Supporting Content for Comment 111 SCMR_CH Limit Adjustment

Jason Ellison, Howard Heck, and Austin
Stegall | TE Connectivity

November 2025 Plenary

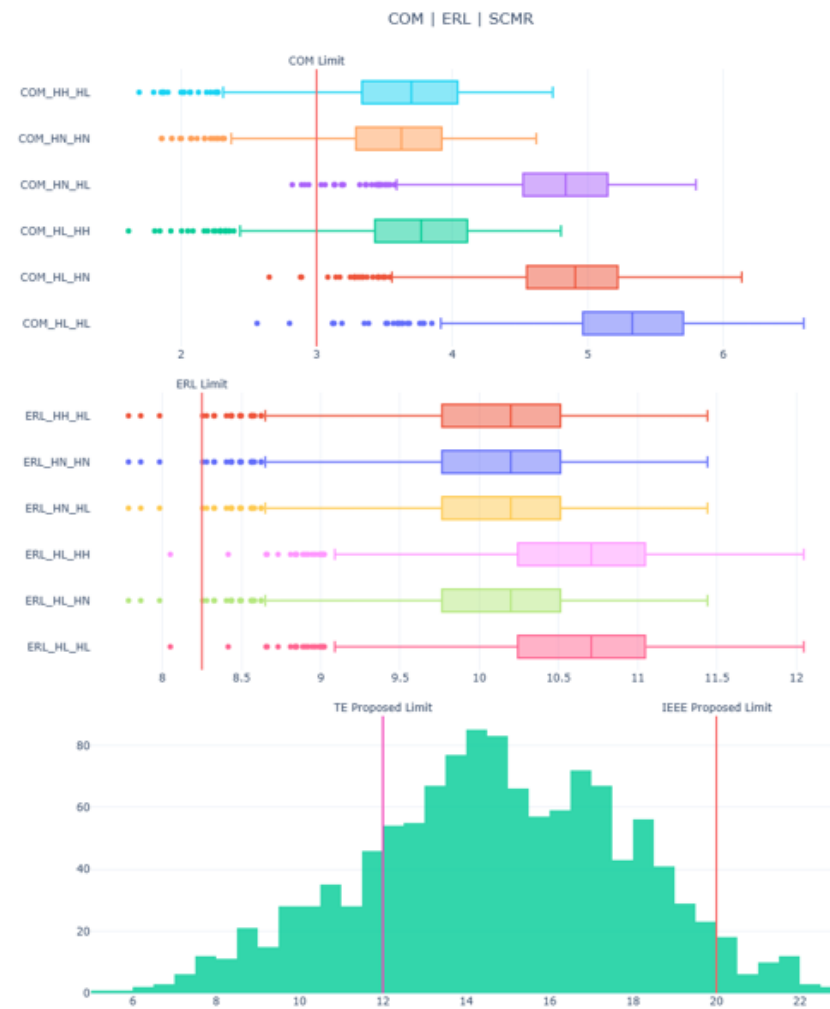
Draft 2.1 introduced Channel Signal to Common-mode ratio, SCMR_CH, as a normative metric in Table 179-14 with minimum limit of 20. Information demonstrating correlation between SCMR_CH and field failures has not been presented.

SCMR_CH was calculated from data of 77 1m OSFP cable assemblies (1232 differential pairs). 4.1% of the differential pairs and 0% of cable assemblies passed this criteria. This is out of alignment with the number of cables passing mode conversion insertion loss from Draft 2.0: 94.93% differential pairs and 66.23% cable assemblies.

The goal is to align the SCMR_CH limit with cable assemblies that are passing mode conversion insertion loss.

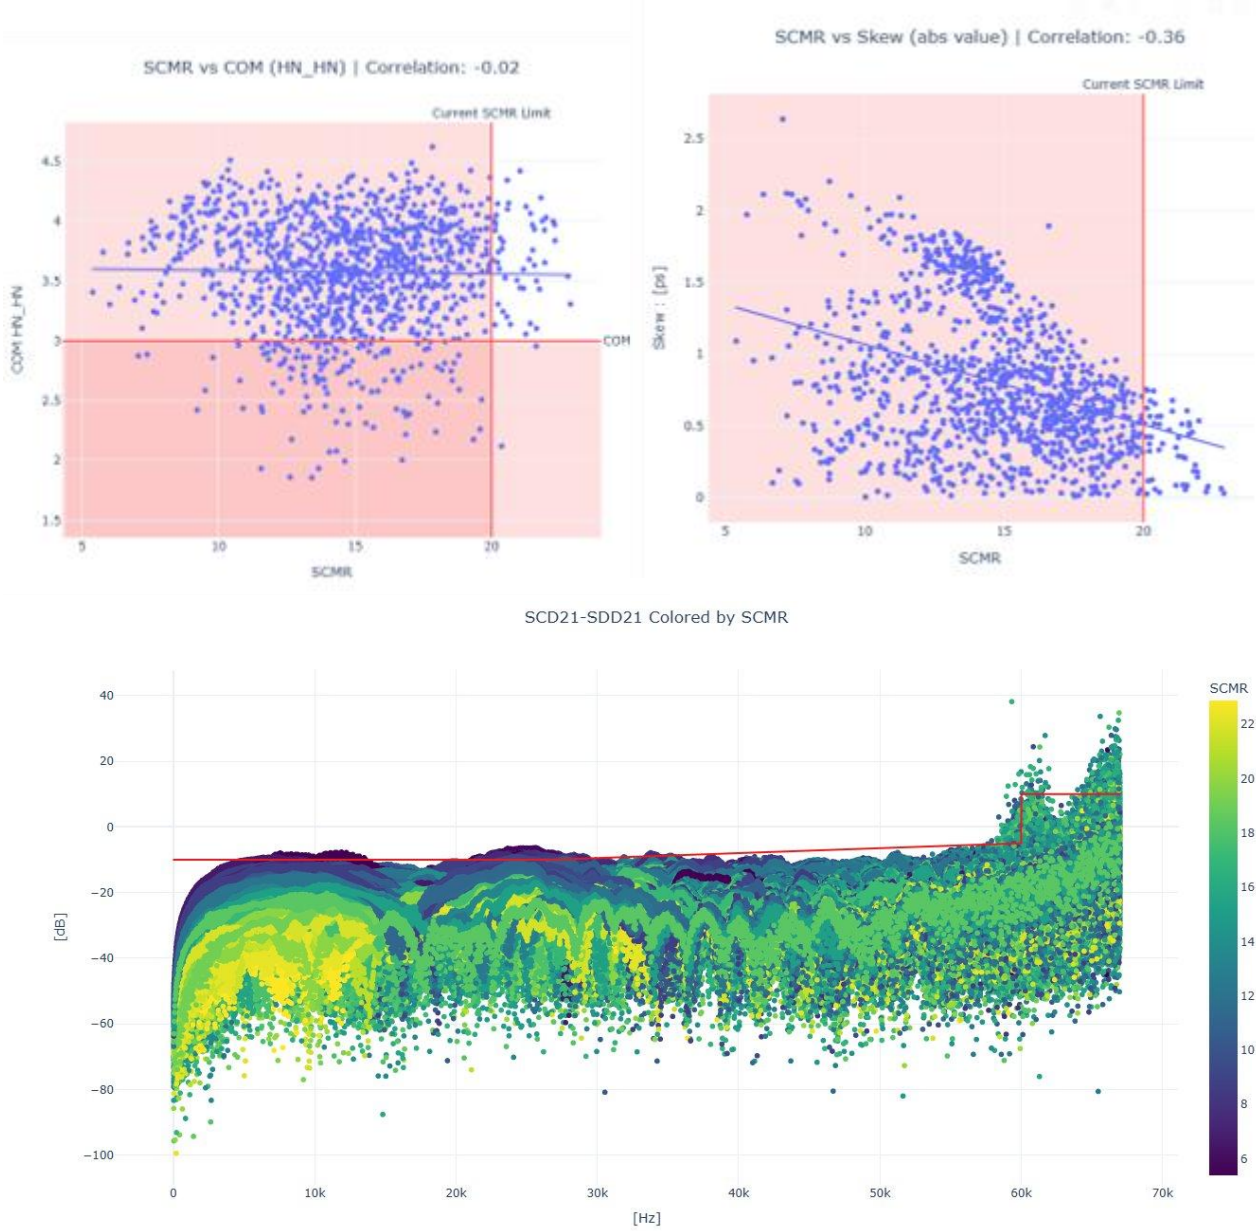
COM is very weakly correlated to SCMR_CH . Meaning, COM is not capturing the effects of skew and imbalance, and another metric such as SCMR_CH is needed.

SCMR_CH is moderately correlated to skew. Which indicates SCMR_CH is capturing the effects of asymmetry reasonably well.

SCMR_CH values trend with mode conversion insertion loss. This indicates SCMR_CH is capturing the effects of mode conversion insertion loss and could be used as a replacement. Further, SCMR_CH values lower than 12.01 are failing the mode conversion insertion loss frequency domain mask limit in D2.0.

Without data to correlate field failures with SCMR_CH, an analysis has been performed to correlate SCMR_CH with The mode conversion insertion loss specification in Draft 2.0. Using this data, it is recommended changing the SCMR_CH minimum limit in table 179-14 to 12.0.

This value has been shown to be consistent with the previous mode conversion insertion loss limit in Draft 2.0 and is consistent with currently available hardware and process capability.
